Japan Comments for Battery Durability GTR

29.June.2020

JAPAN Proposals and Comments

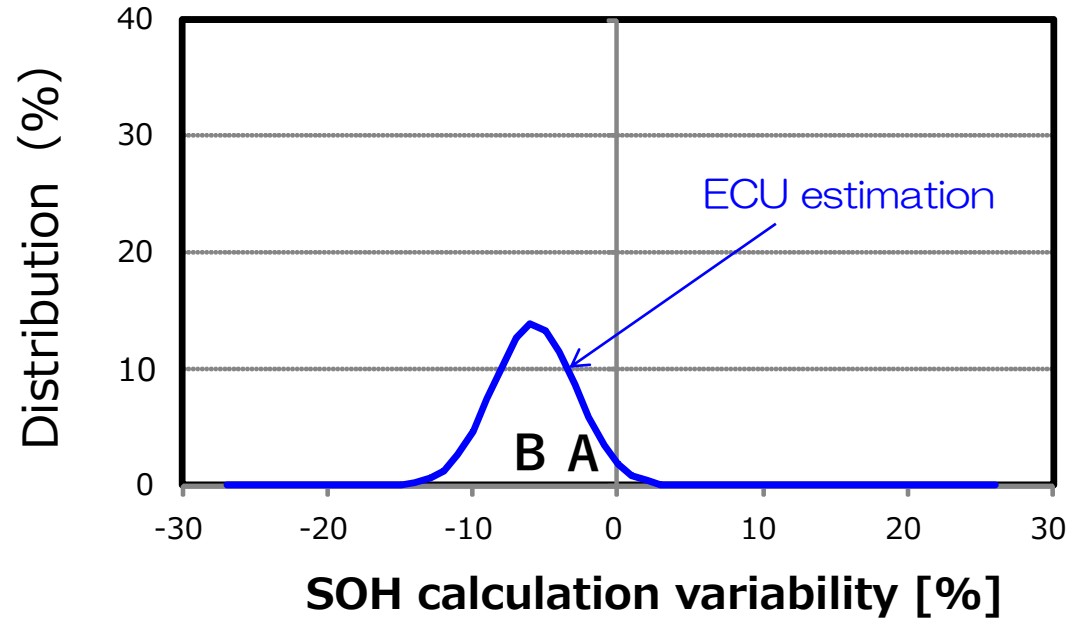
5. Concerns that the Li battery degrades quickly in the initial stage. (Page 11)

Need to share this issue and Discuss how to manage at the EVE.

Since the initial degradation of the Li battery is rapid and large, SOH indicator might cause user anxiety.

About the initial degradation,

- (1) Need to communicate to consumers appropriately.
- (2) Since consumers are not necessarily able to understand it, the SOH indicator system should be designed so as not to raise concerns about initial degradation.

Pass or Fail Range/SOH: example

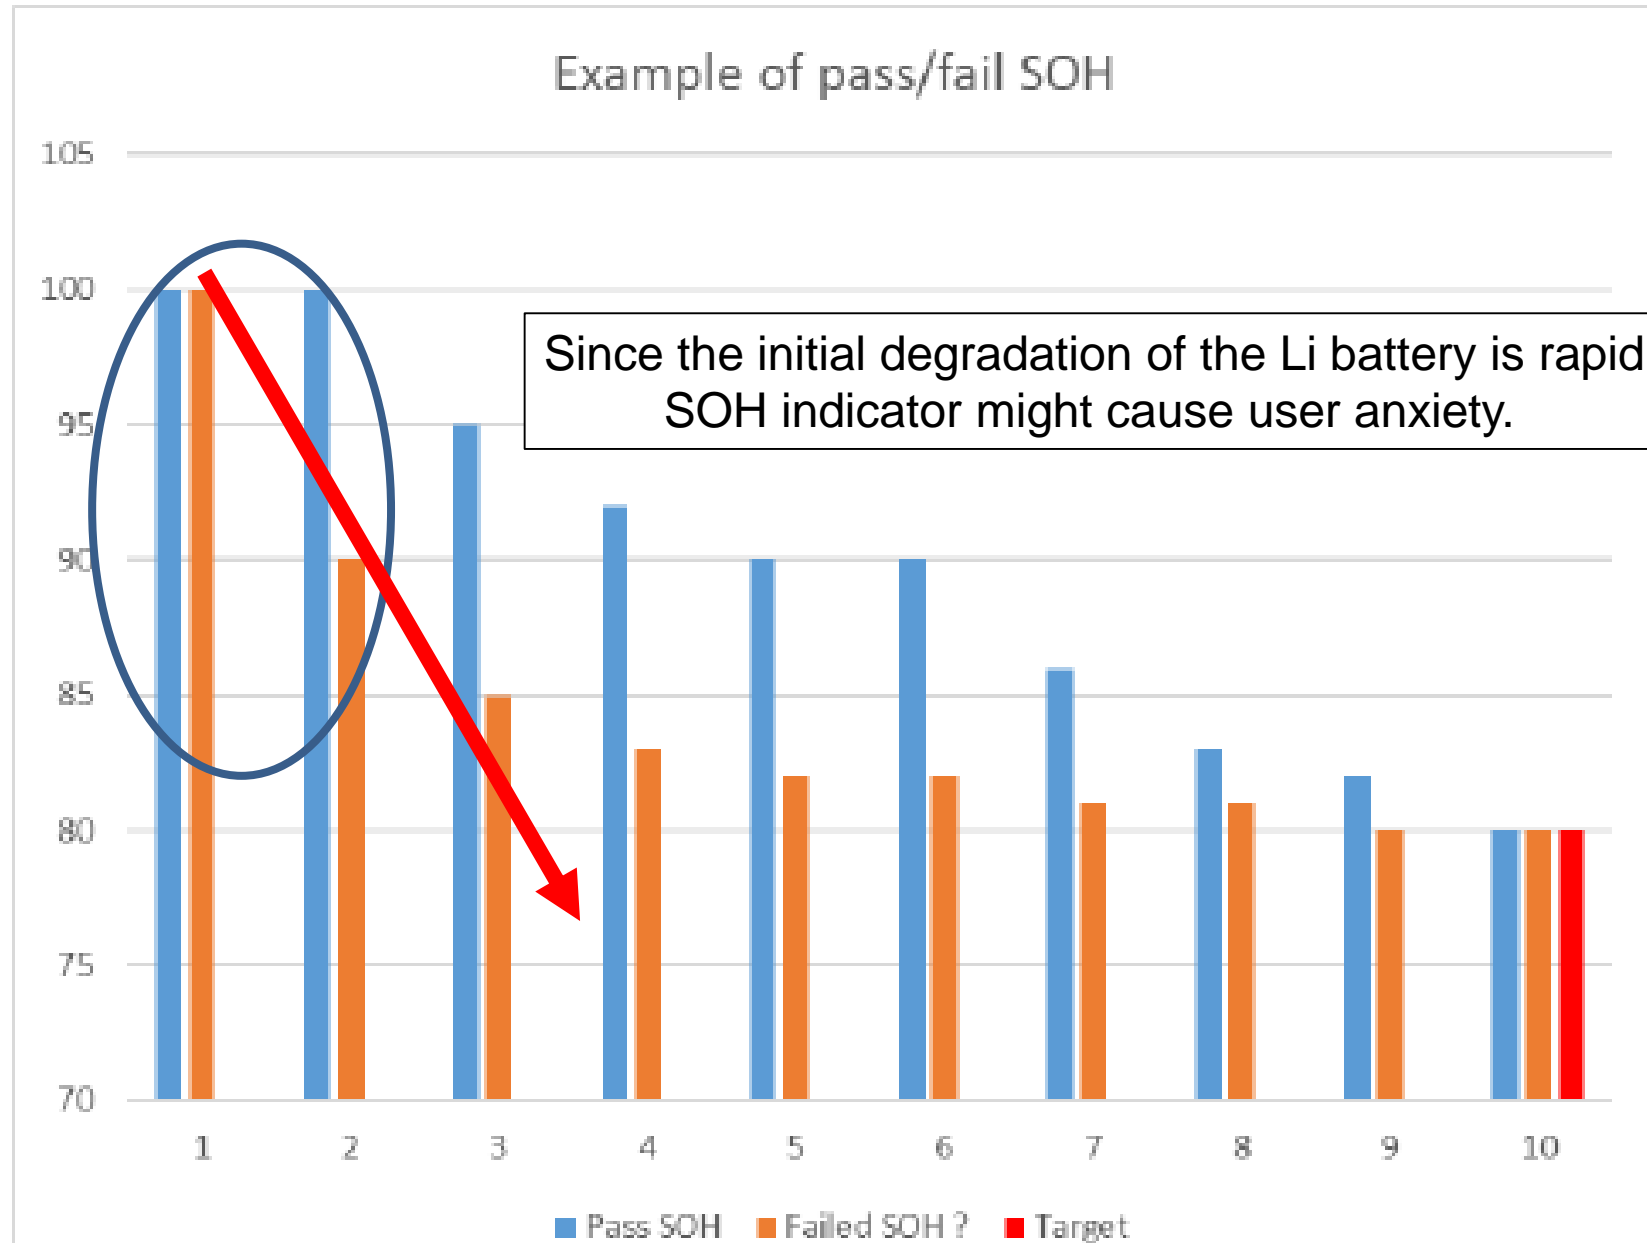
Although the variation of the distance method is sufficiently low
The variation of the capacity method is even smaller.

Variation factor for Range method

- 1.driver's operation
- 2.acceptable operation within the WLTP
